Surma Garments Ltd. #10261

Supasox Ltd. #9535

Aicha Noadda, Rajashon Road Savar, Dhaka
(+23.8473927N, 90.265607E)
06.MAY.2014

Identified Priority 1 Concerns

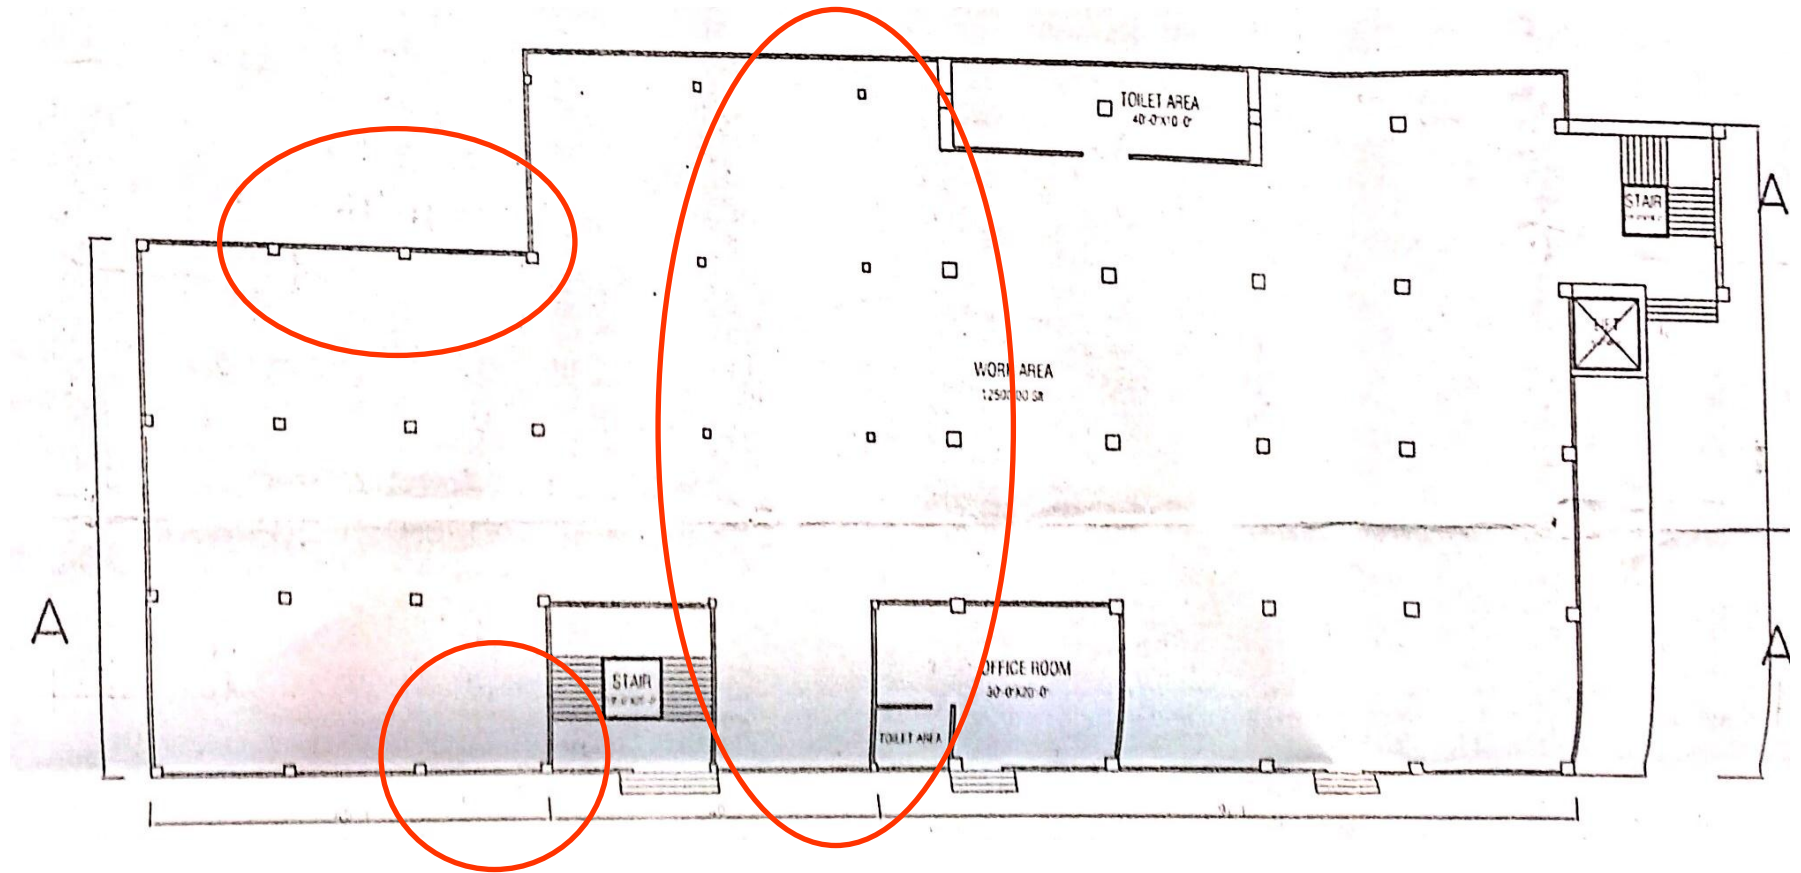
The structural drawings do not match the existing conditions for all buildings

- Structural Engineer to survey existing conditions and update drawings to match actual condition.

SHALLOW FOUNDATION as Isolated column footing:

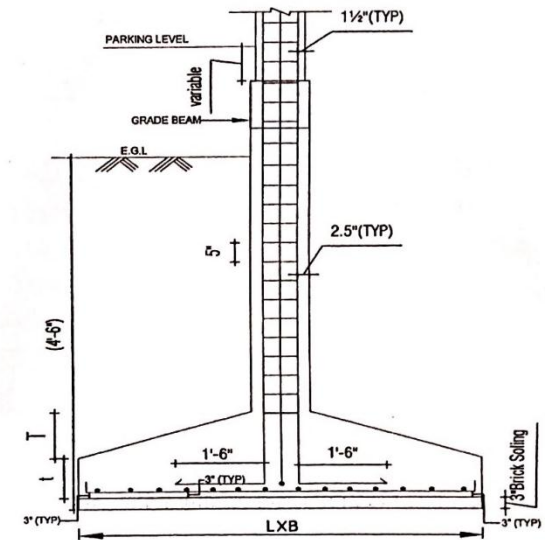
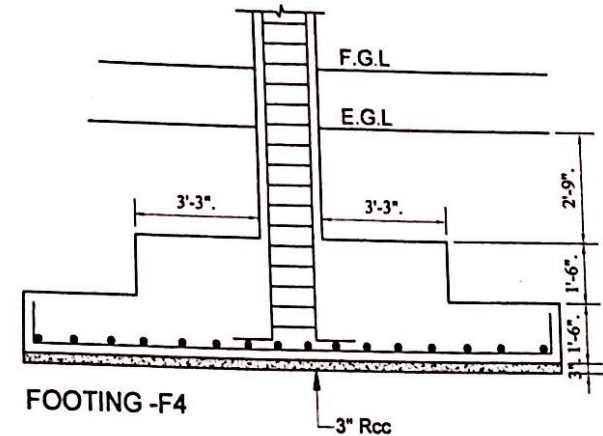
The average bearing capacity of the Shallow Foundation as Isolated column footing may be considered in the following way:

- To be considered **1.60 Tsf** (F.S. = 2.50) at a depth of **9 ft** measured from EGL particularly at and around for BH-1, BH-2, BH-3 & BH-4 only.
- To be considered **1.40 Tsf** (F.S. = 2.50) at a depth of **9 ft** measured from EGL particularly at and around for BH-5 only.

OR

- To be considered **1.60 Tsf** (F.S. = 2.50) at a depth of **12 ft** measured from EGL particularly at and around for BH-5 only.

The recommendations from the soils report were not executed. The footings were constructed between 3'6" and 4'9". The soils report recommended a footing depth of 9'.

- We recommend a geotechnical investigation be completed to determine the exact footing depths of all buildings.

- A second geotechnical investigation be completed to ensure adequate bearing capacity for all buildings.

TYP. SEC. OF R.C.C. FOOTING & PEDASTAL.

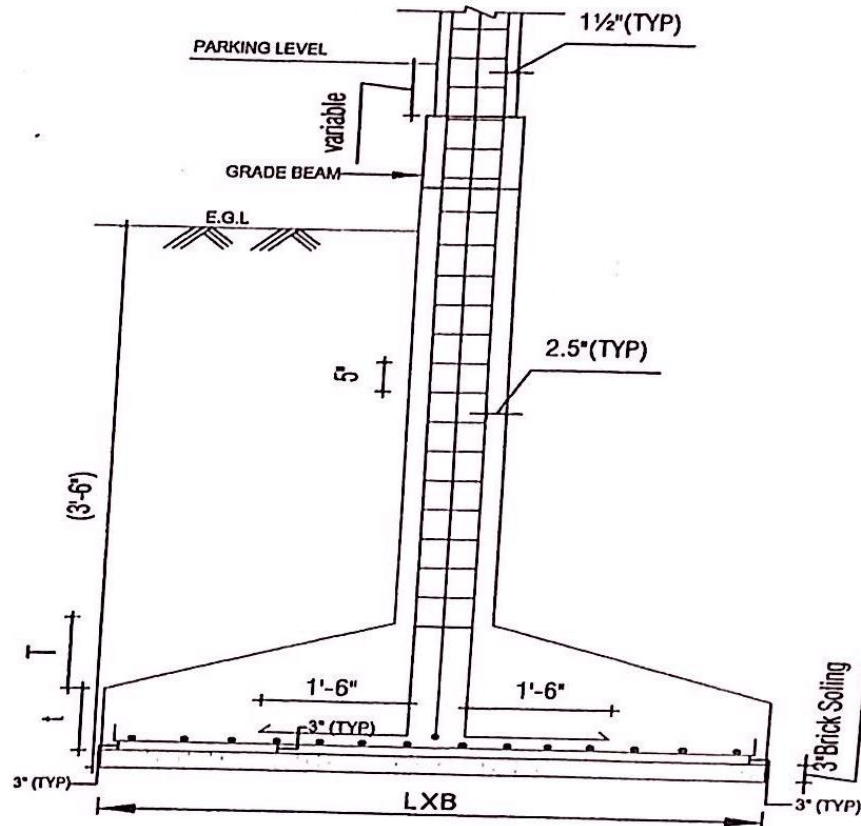
Footing size for critical column is 7' x 7'.

Load on critical column based on column rundown = 897 kN.

Pressure on soil = 197 kPa.

Allowable bearing capacity based on soils report = 150 kPa (FOS = 2.5).

Reduced FOS = 1.9.

Footing size at critical column appears too small for Building A.

- Detail Engineering Assessments are required for the above mentioned items.
